PLANNING AND ZONING COMMISSION MEETING – AMENDED*

Tuesday, April 12, 2016 • 7:30 p.m.

The Meadows Subdivision
Phase 2

Preliminary Plat Checklist

GRADING AND EROSION CONTROL PLAN

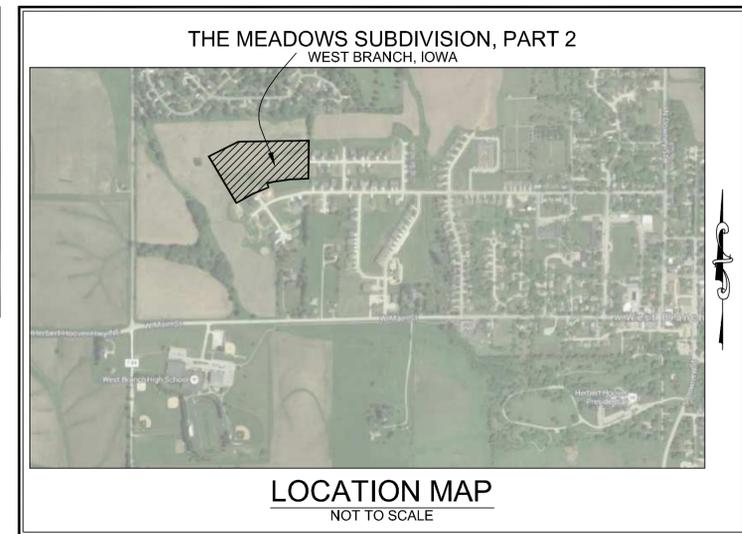
Item 18. Identification of areas prone to erosion and, by separate document attached to the preliminary plat, a grading plan to explain the methods that will be used to control erosion pursuant to the requirements of this chapter. (See Section 170.15(15))

Answer: **Paul Anderson has corresponded with Dave Schechinger. Sedimentation basins have been added on Lots 20 and 41. A construction entrance has also been added.**

PRELIMINARY PLAT

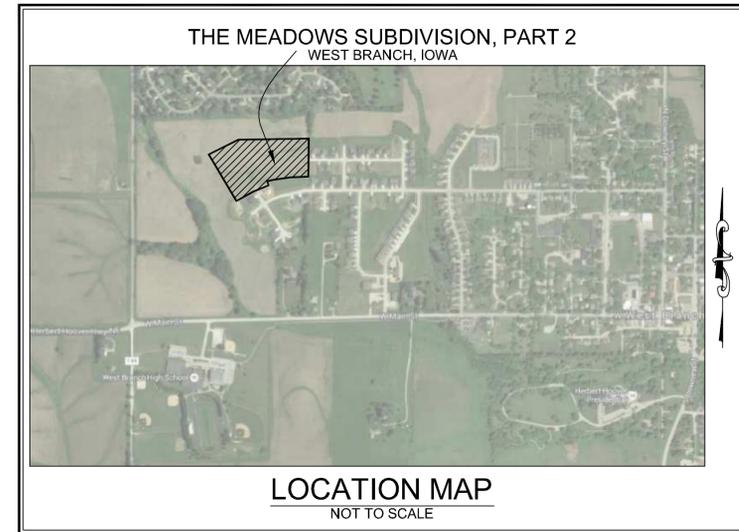
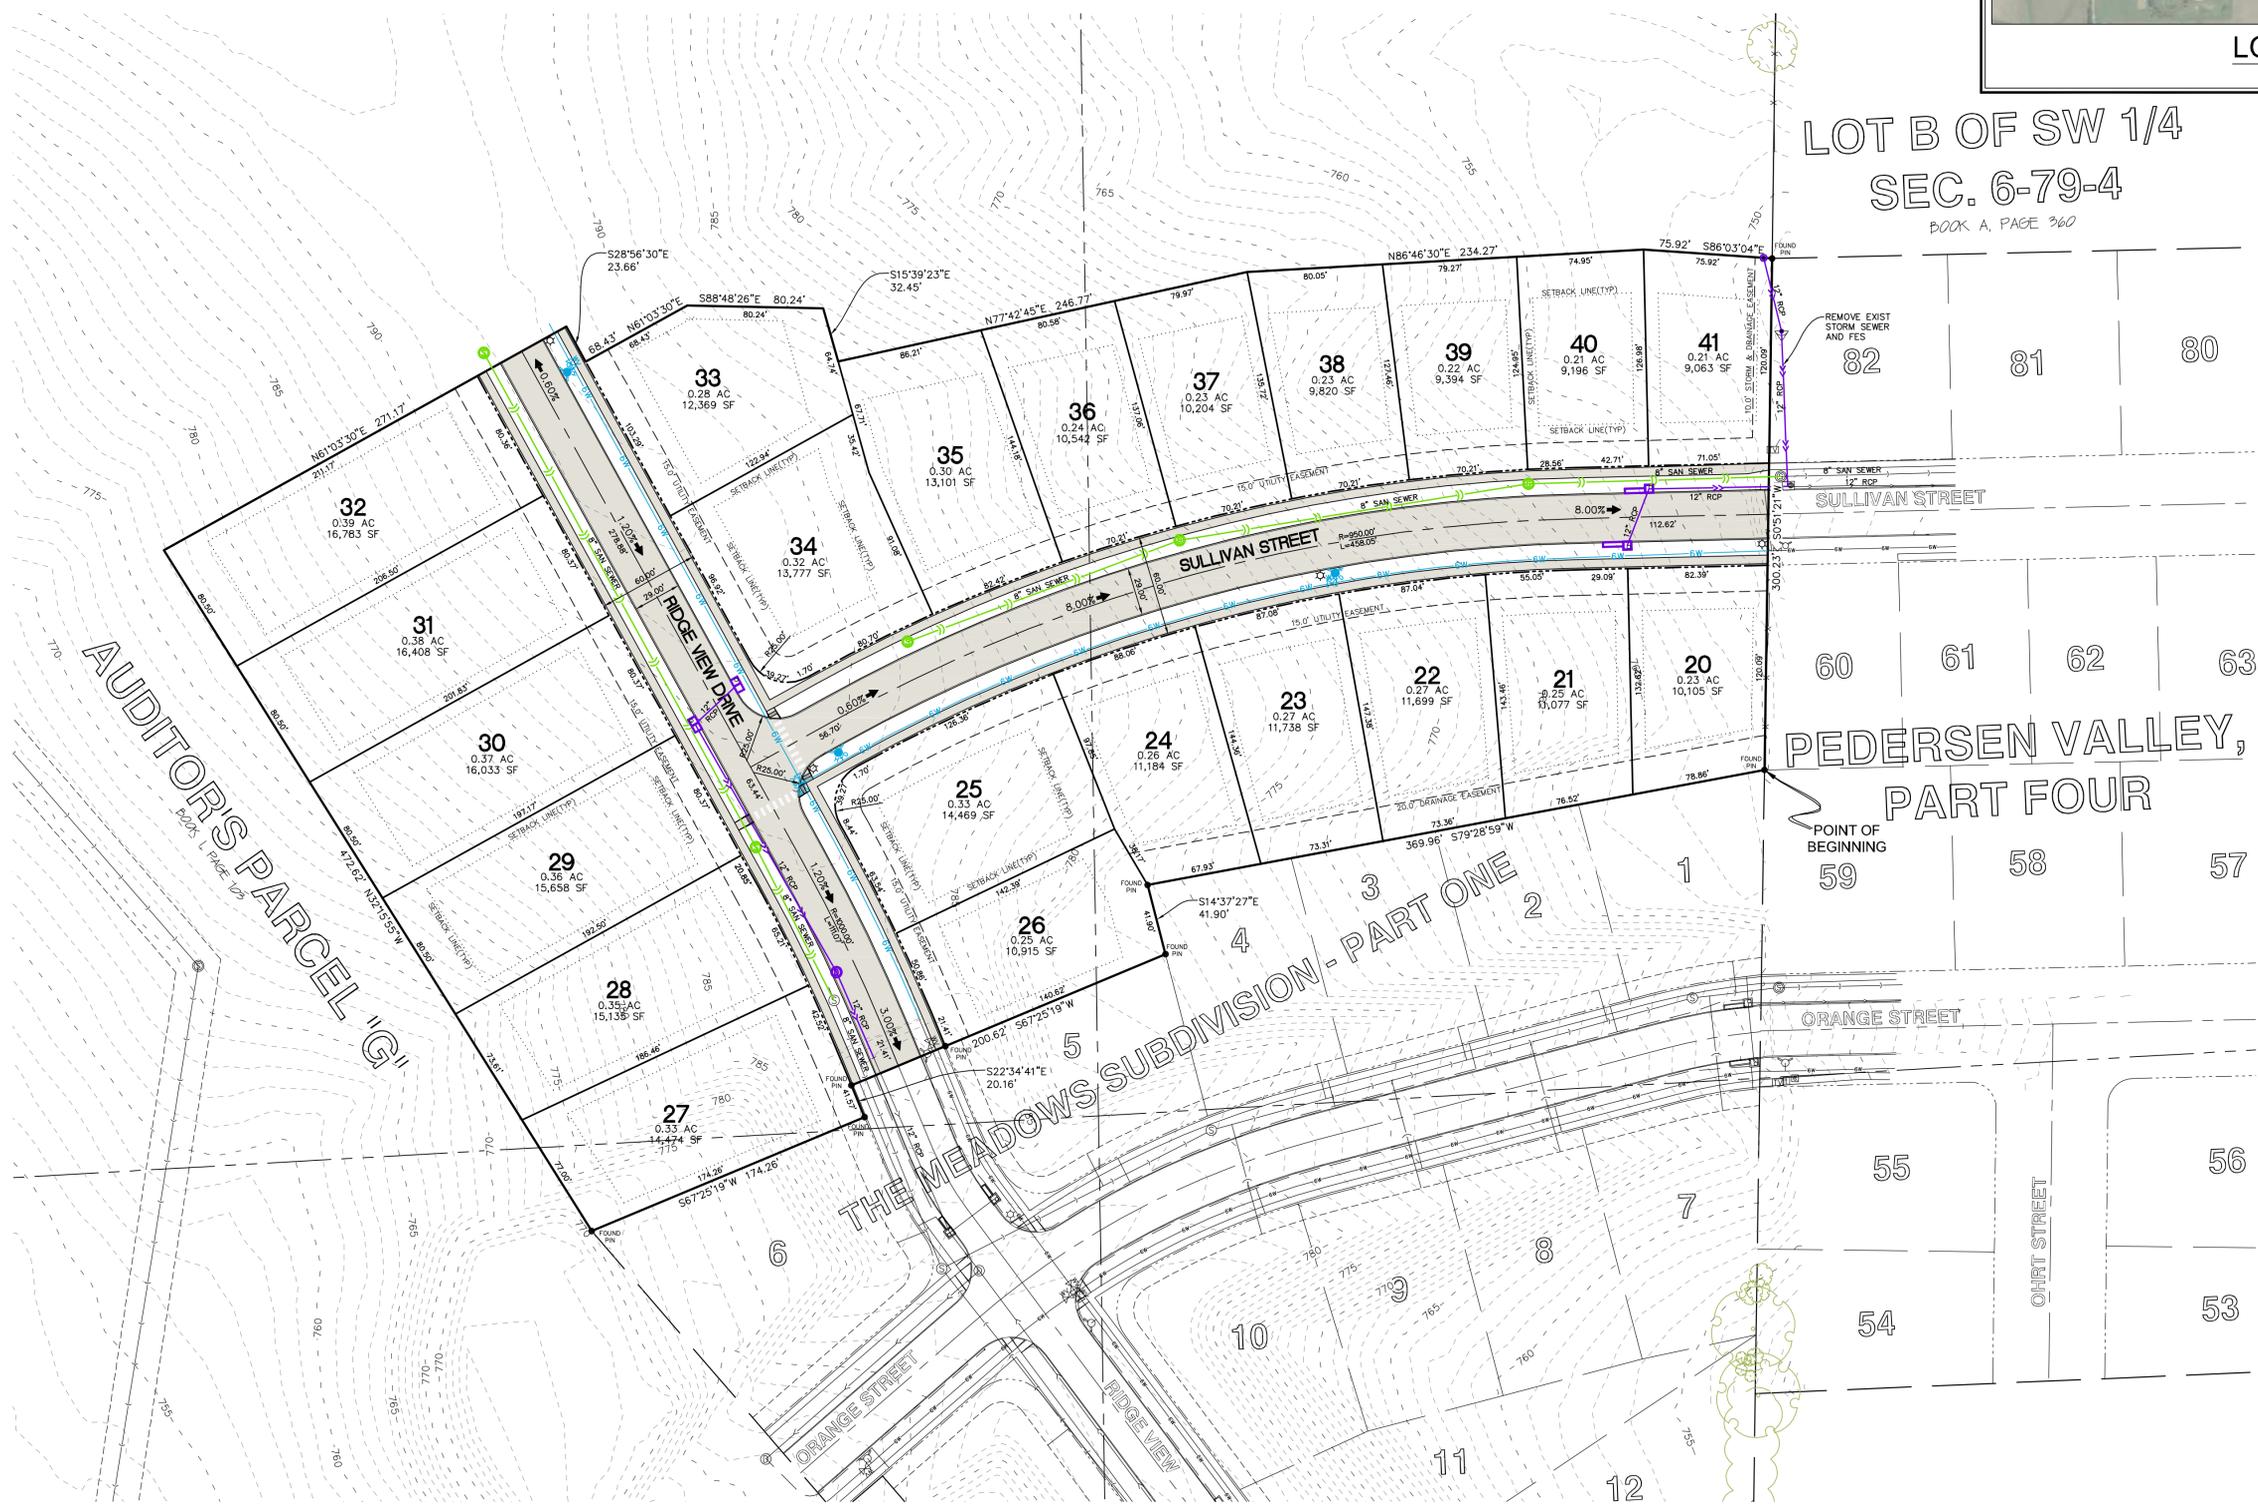
Comments: Provide drainage easements for Stormwater to flow along lot 41 and south of lots 20-24

Answer: A proposed 10’ storm and drainage easement have been added to the east line of Lot 41 and a 20’ storm drainage easement has been added to the south end of Lots 20 through 24.
